DOCUMENT NO. 80SDS4244
APRIL 1981
REV. 2

HYDROGEN CONTAINMENT ANALYZER
QUALIFICATION AND PERFORMANCE
TEST REPORT

CUSTOMER/PROJECT SCE/SONG 2, 3		PRODUCT NAME CONTAINMENT POST LOCA H ₂ MONITORING SYSTEM QUALIFICATION REPORT	
PURCHASE ORDER NO. V4109581	REV. 2	PURCHASE ORDER ITEM(S) NO. 4	QUANTITY 6
<p align="center">SUPPLIER'S CERTIFICATION</p> <p>THIS IS TO CERTIFY THAT THE PRODUCTS IDENTIFIED HEREIN HAVE BEEN MANUFACTURED UNDER A CONTROLLED QUALITY ASSURANCE PROGRAM AND ARE IN CONFORMANCE WITH THE PROCUREMENT QUALITY REQUIREMENTS INCLUDING APPLICABLE CODES, STANDARDS AND SPECIFICATIONS AS IDENTIFIED IN THE ABOVE-REFERENCED DOCUMENTS; UNLESS NOTED BELOW. ANY SUPPORTING DOCUMENTATION WILL BE FORWARDED OR RETAINED IN ACCORDANCE WITH PURCHASE ORDER REQUIREMENTS.</p> <p>SIGNED: <u>J.E. Murphy</u> DATE: <u>10-23-80</u> TITLE: <u>J.E. MURPHY</u> ORGANIZATION: <u>GE-SD</u> <u>QC PROJECT ENGINEER</u></p> <p>NONCONFORMANCES FROM PROCUREMENT QUALITY REQUIREMENTS:</p> <p>NONE</p> <p>REMARKS/EQUIPMENT SERIAL NUMBERS:</p> <p>DOCUMENT NUMBER 80SDS4244</p> <p align="right">5023-508-17-10-0</p>

Figure 4. Signal Conditioning Assembly

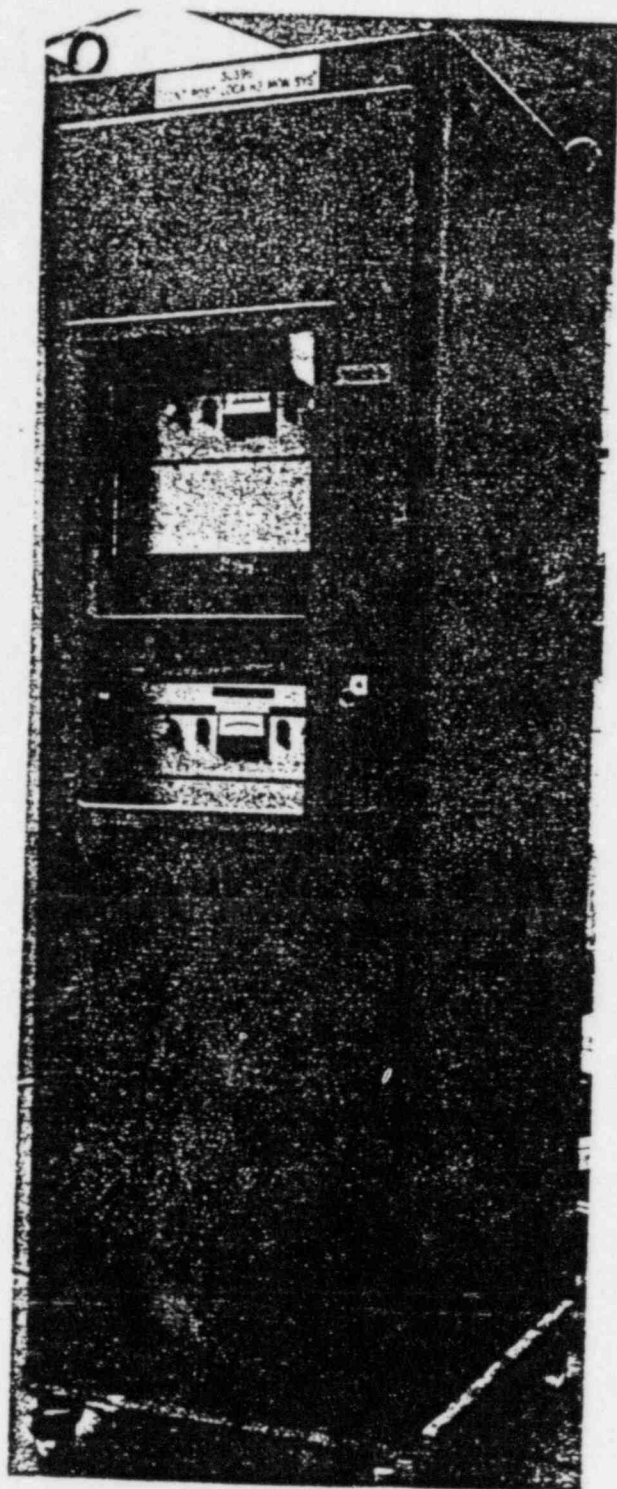
It is not evident that the system described in A's 1.3.3 and 1.3.4 is that which was supplied to SONGS 2&3. Please clarify.
